**TOWN OF MOUNTAIN VILLAGE
SPECIAL DESIGN REVIEW BOARD MEETING
AGENDA**

TO: Mountain Village Design Review Board

FOR: Special Design Review Board Public Hearing; February 11, 2021
(continued from February 4, 2021)

VARIANCE REQUESTED

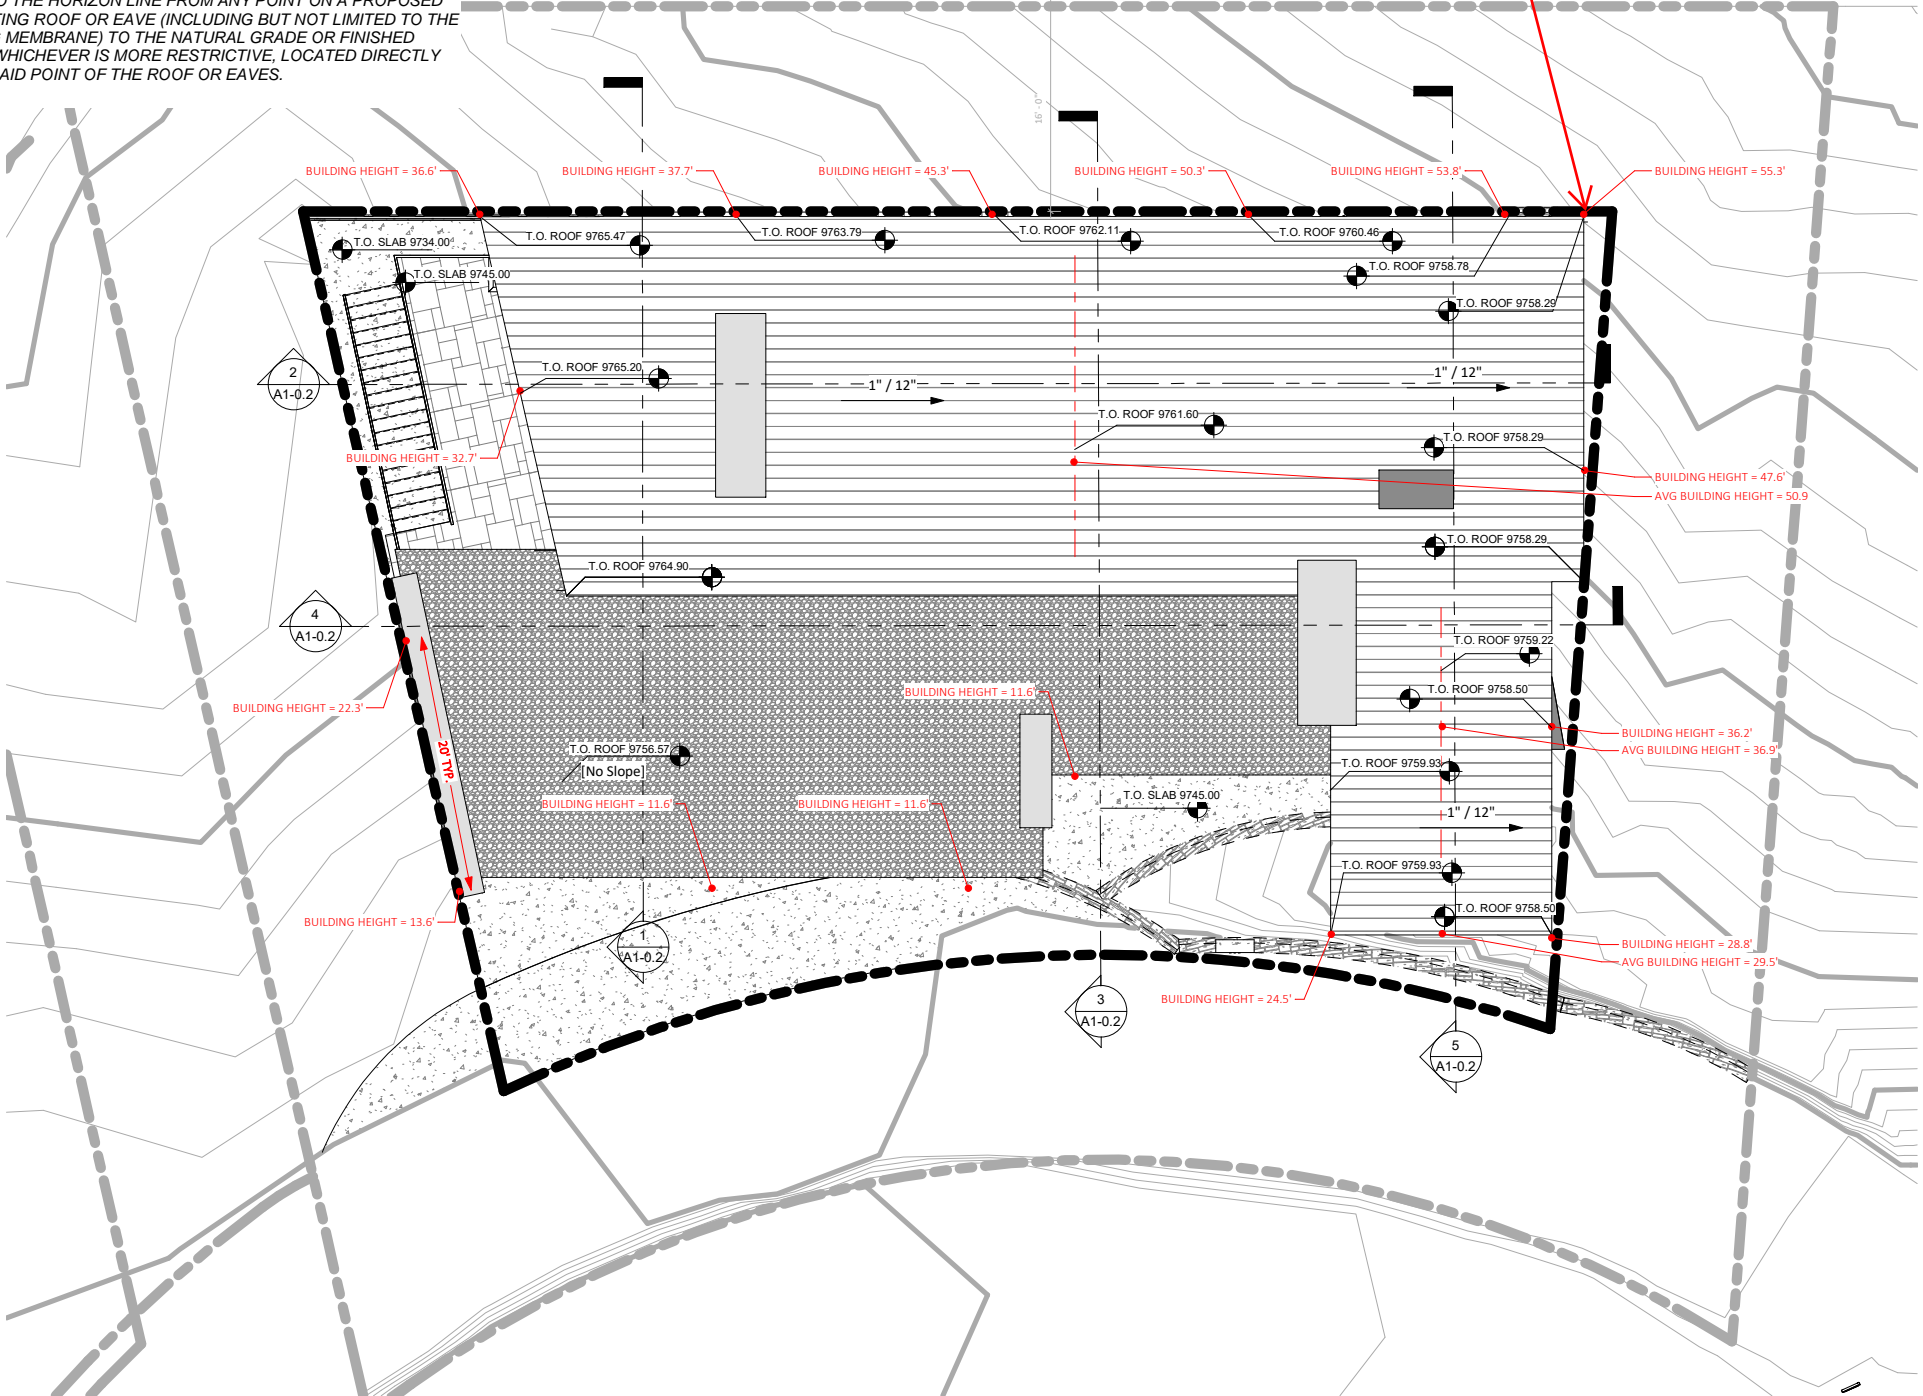
As such, the applicants have again updated their plans to reduce both the Maximum Building Height as well as the Average Building Height. Based on the heights provided as part of the updated documents, the maximum building height as proposed is now at 50'-9" (+15'-9") from the highest ridge to the grade below and the maximum average building height is shown at 31'-6" (+1'-6"). As part of the height analysis and variance request, the

applicant has provided a parallel plane graphic demonstrating the portions of the home penetrating the 35-foot parallel slope height allowance for shed roof forms. Because the heights exceed the CDC requirements, the applicant will be required to obtain Town Council approval of a variance to allow for these requests.

Based on the attached plan set, it appears that the design was reduced by approximately five feet from the February 4, 2021 hearing for a total of 50'-9" rather than 55'-4". Staff will discuss this request in more detail below under the provisions related the criteria for variance approval. If the DRB determines the height appropriate, then there shall be a condition of approval which shall require a survey prior to framing inspections in order to demonstrate compliance with maximum heights.

C1-0.2
DRB DRAINAGE

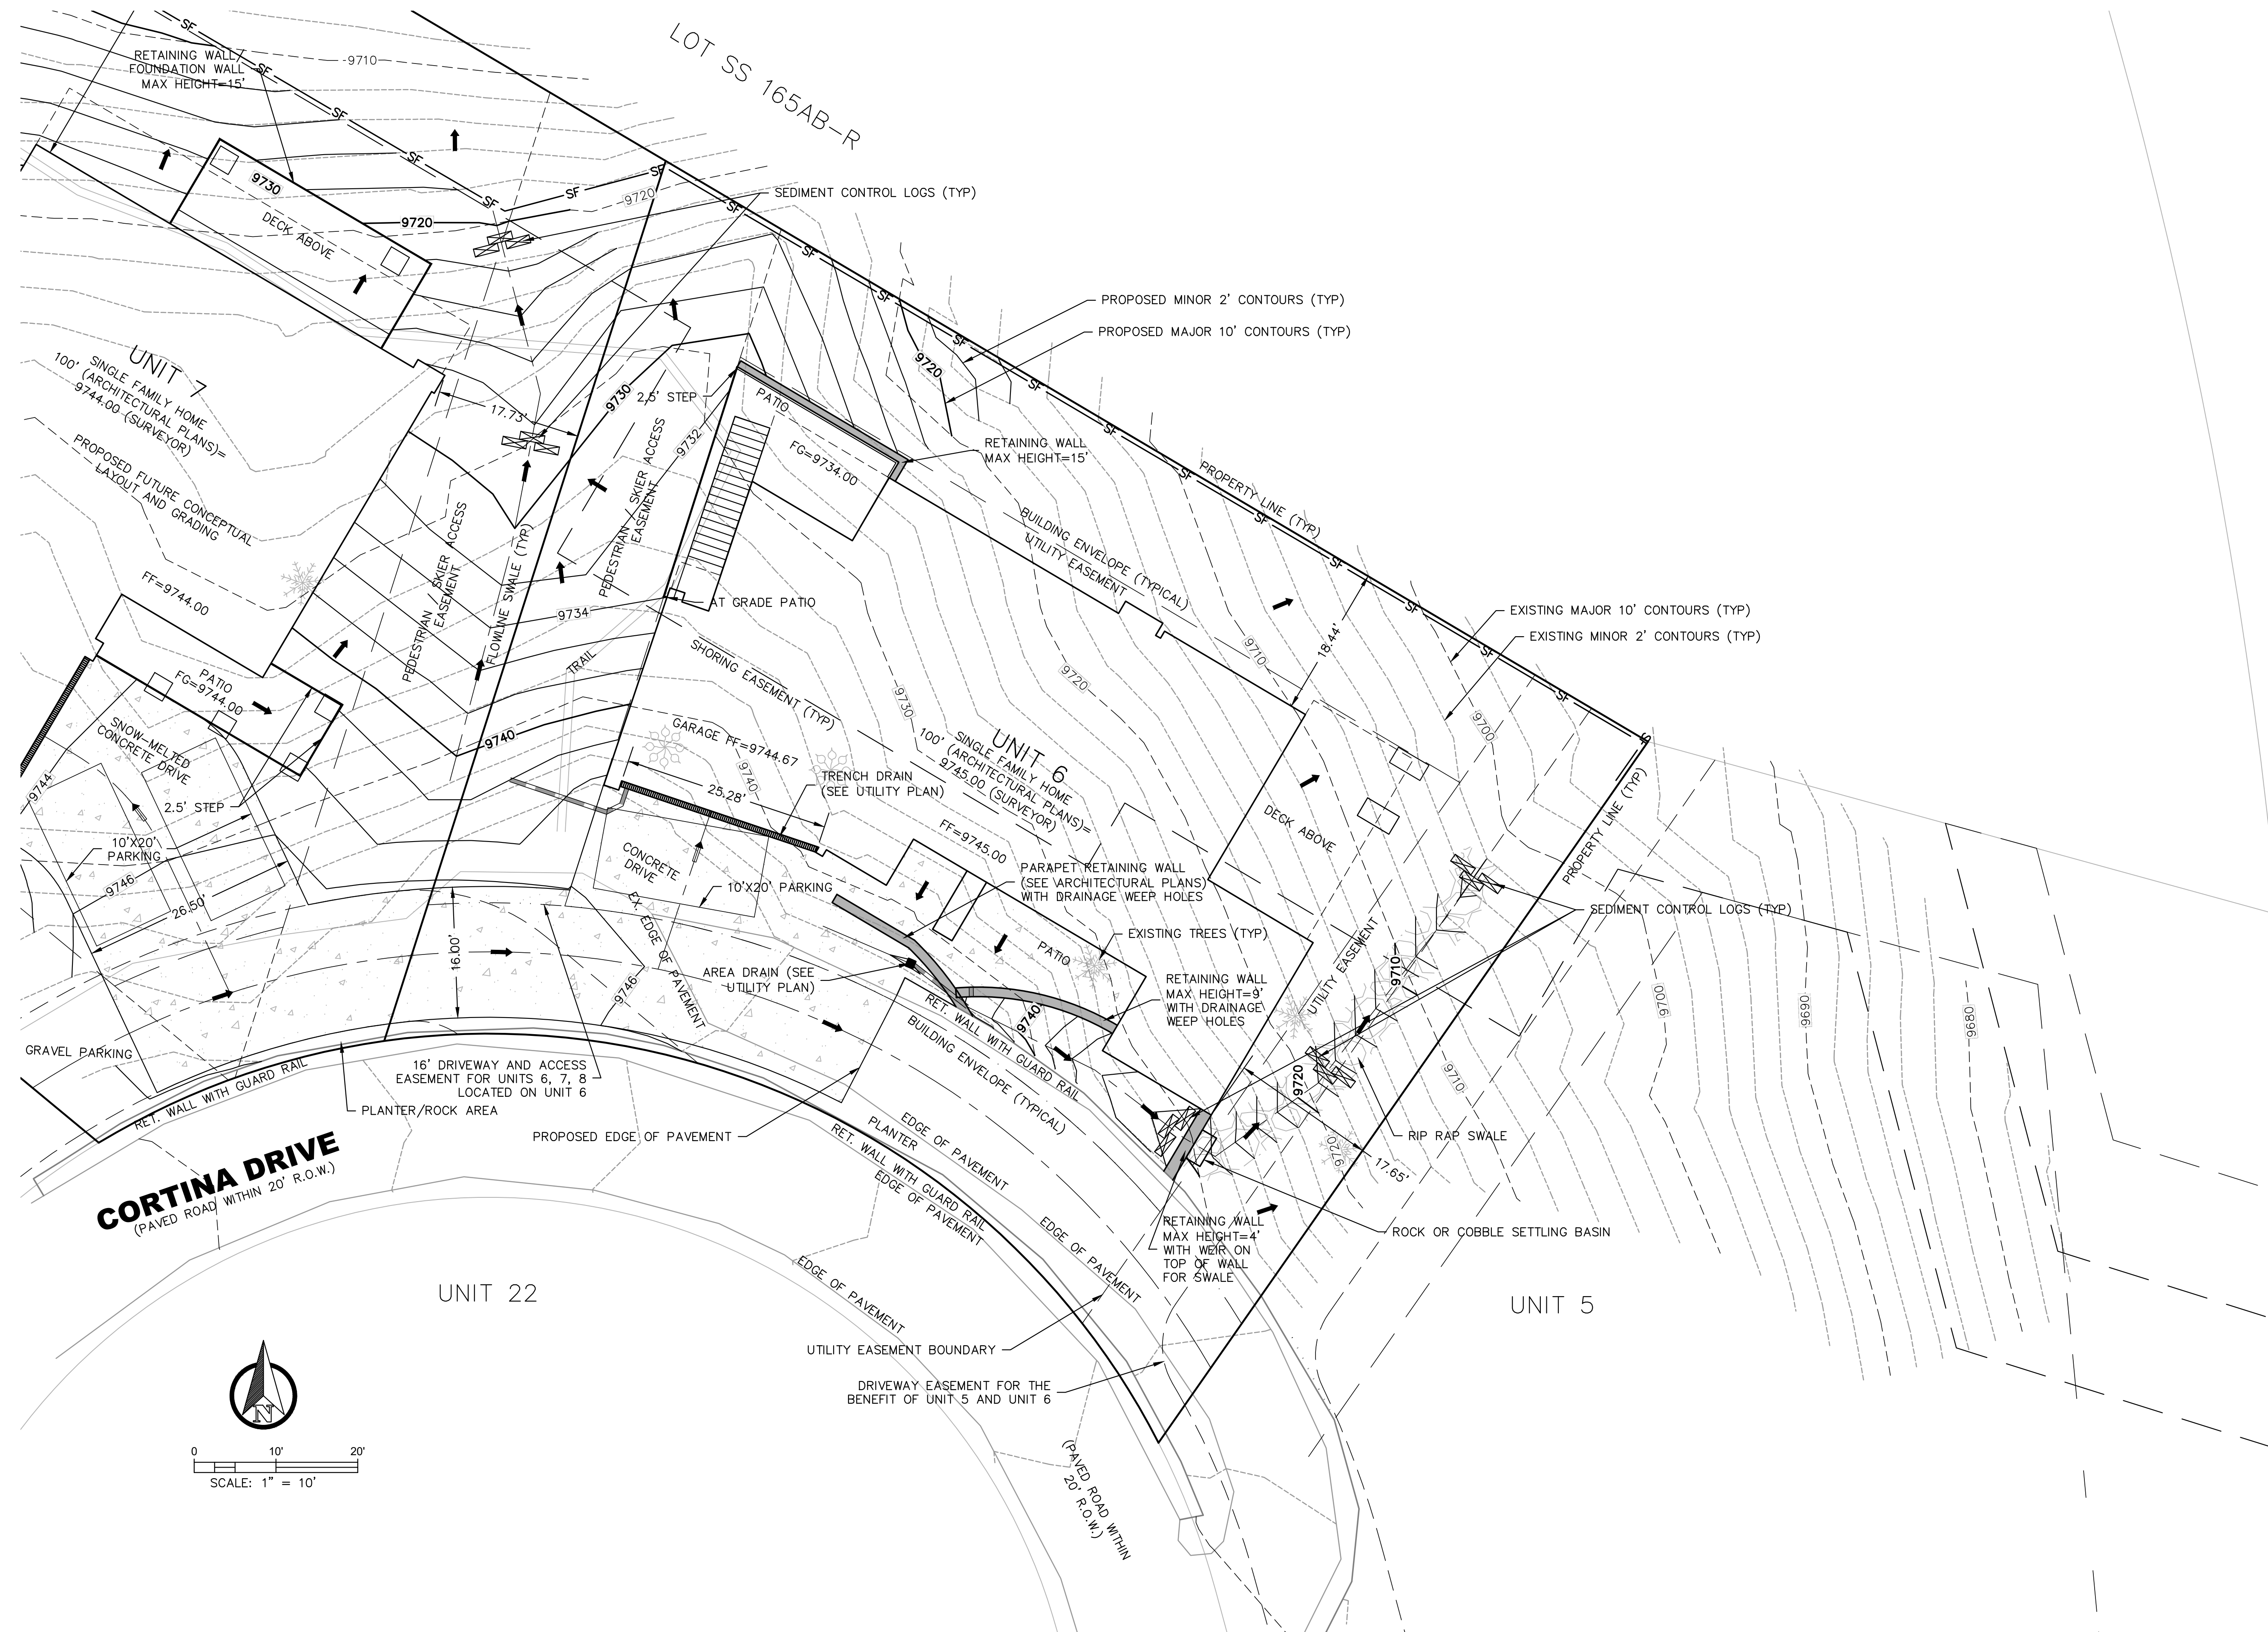
Staff: The applicant has provided a conceptual grading and drainage plan provided by Alpine Land Consulting, LLC. The proposal provides positive drainage for the residence as well as delineating disturbed areas including the driveway and areas surrounding the home. As required by the CDC, all disturbed areas are to have final grades of 2:1 or less, and these criteria appear to be met. As noted above, grading has been proposed within the setbacks between Units 6-7 and it would be preferable to understand how the development of Unit 6 and the associated grading is accomplished absent or independent of any grading on the undeveloped Unit 7.

- 4) Prior to submittal for Final Architectural Review, the civil engineering plans shall be updated to demonstrate the grading and drainage for Unit 6 independently of Unit 7. In addition, the driveway/accessway length, grades, and width shall be demonstrated.

DRB UTILITY PLAN

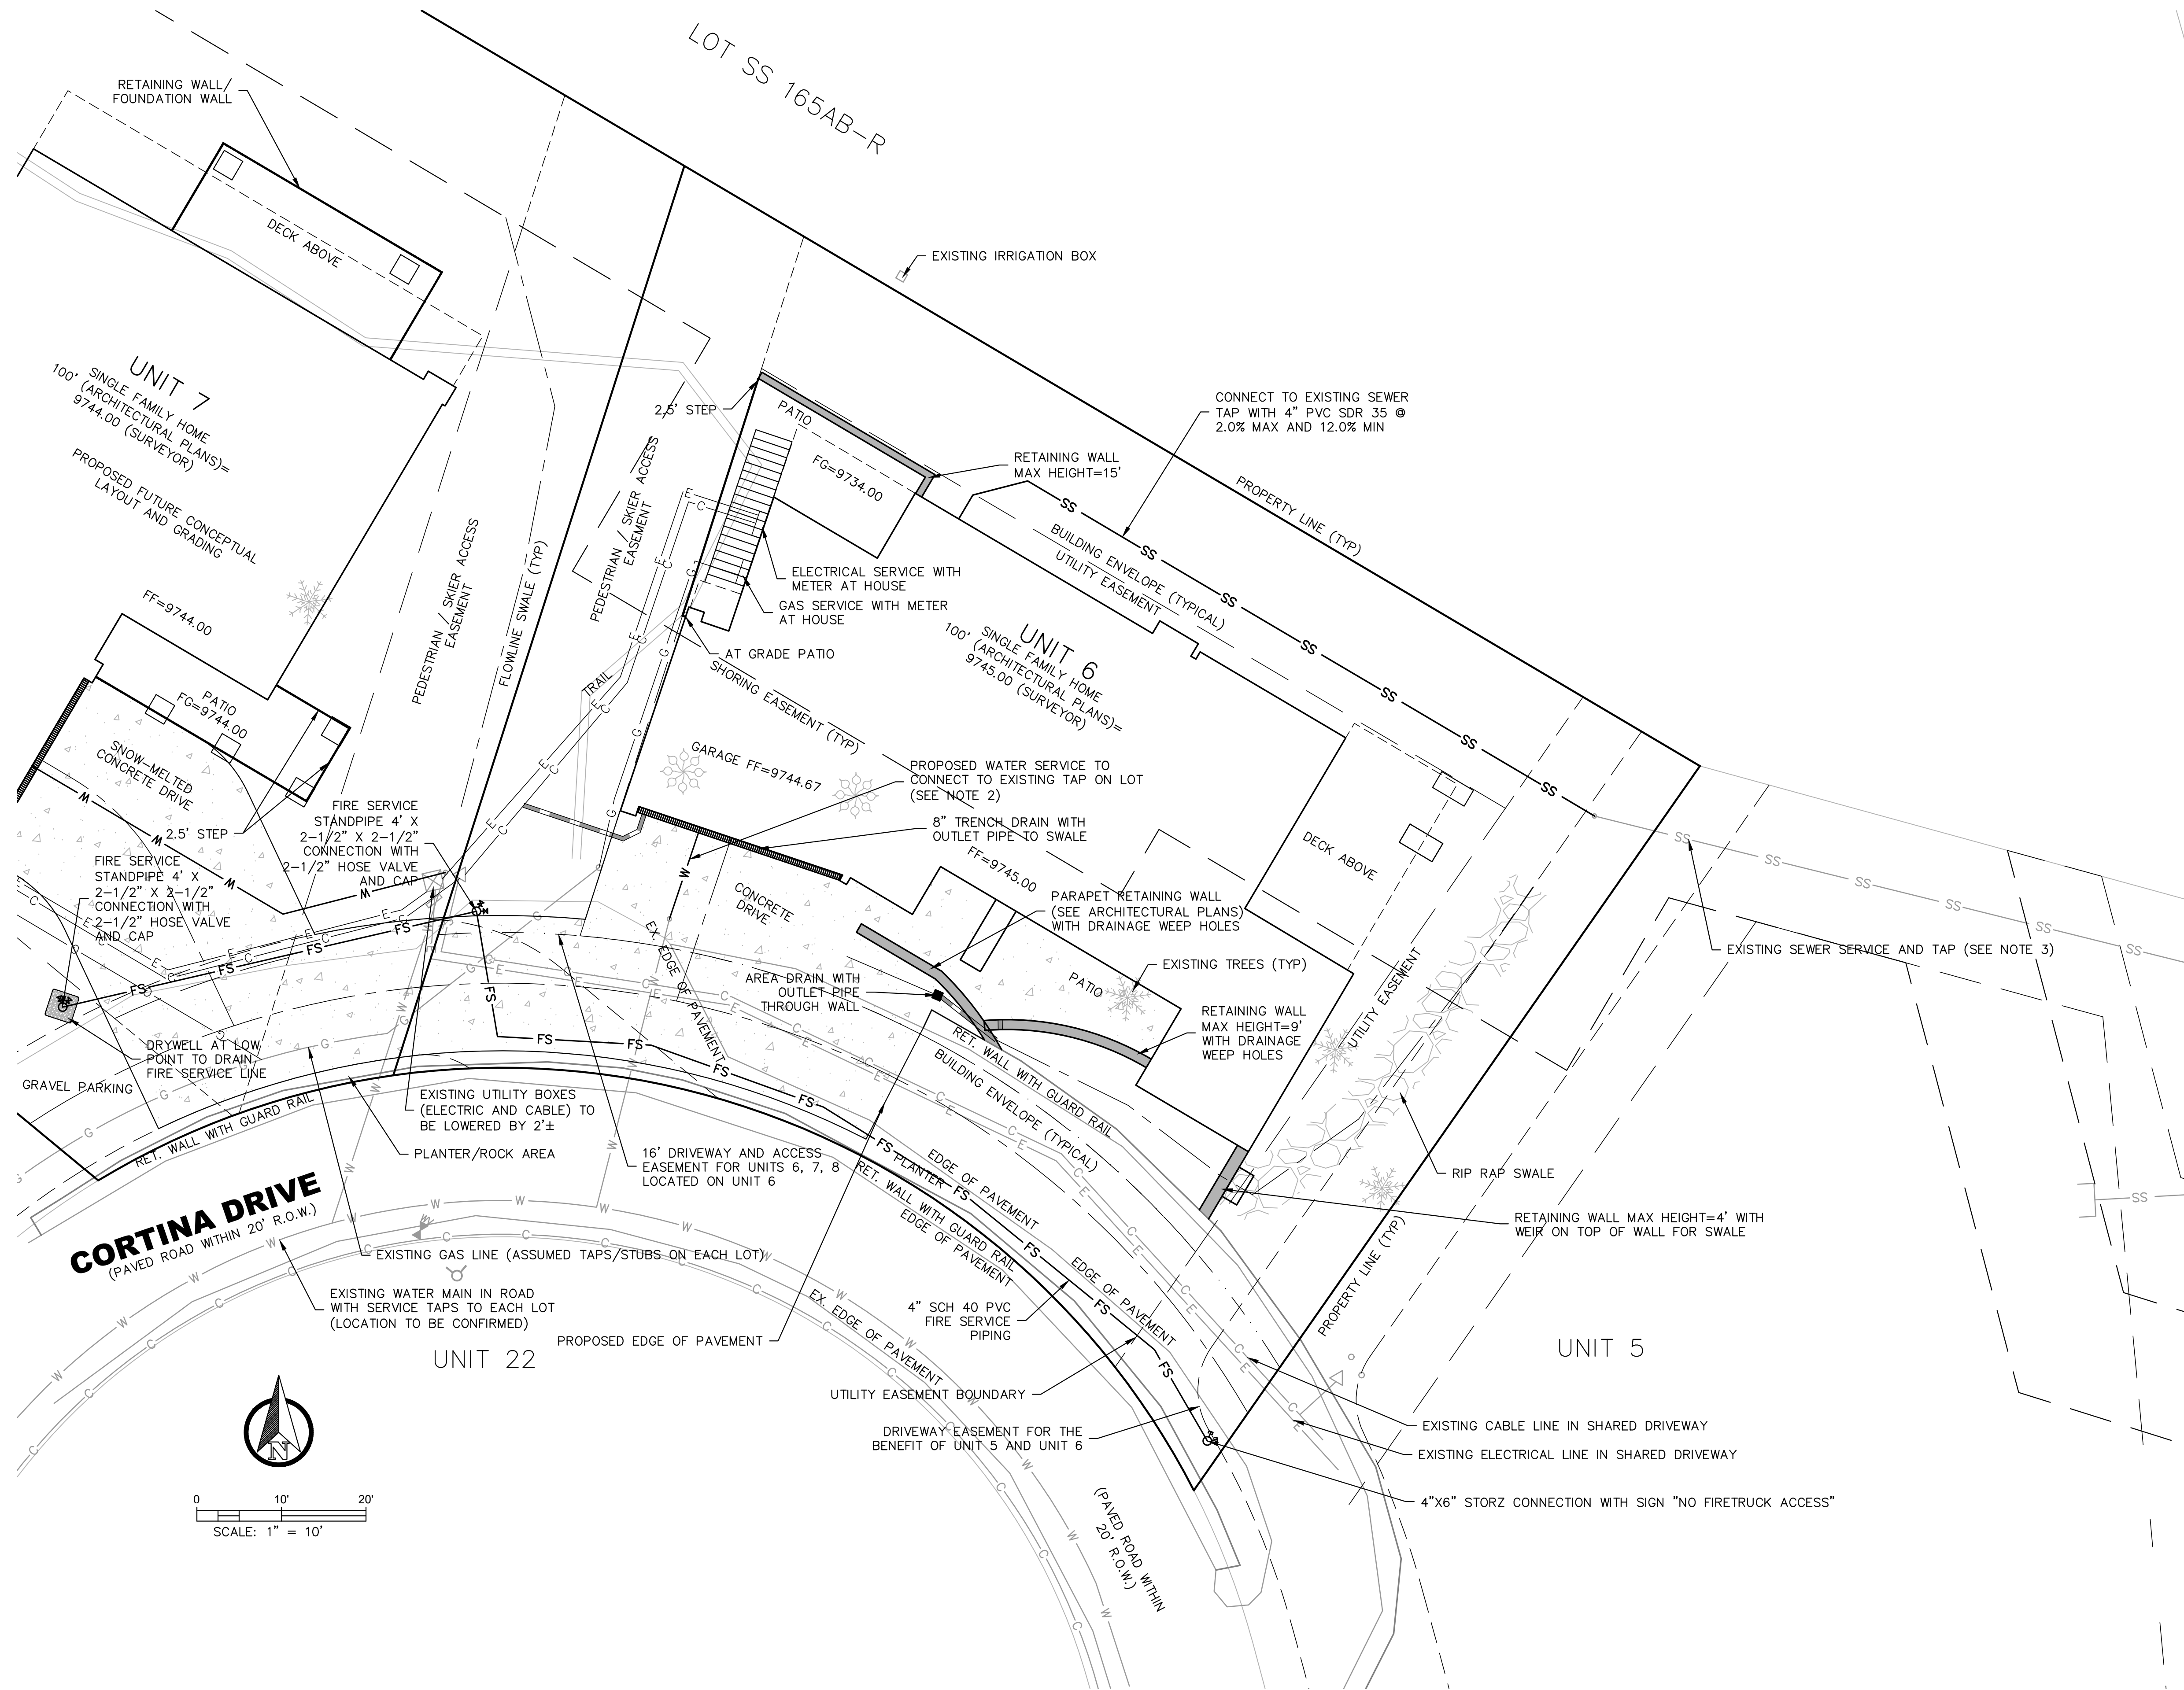
Staff: All utilities are currently located within proximity to the home. The applicant shall work with the Public Works Director before the final review to verify the specific locations of the connections for the home. The plan set shows the proposed connections and the locations of the proposed utilities based on field research.

- 5) Prior to the issuance of a building permit, the applicant shall field verify all utilities and submit a revised utility plan to the public works director identifying the location of utilities and connection points.
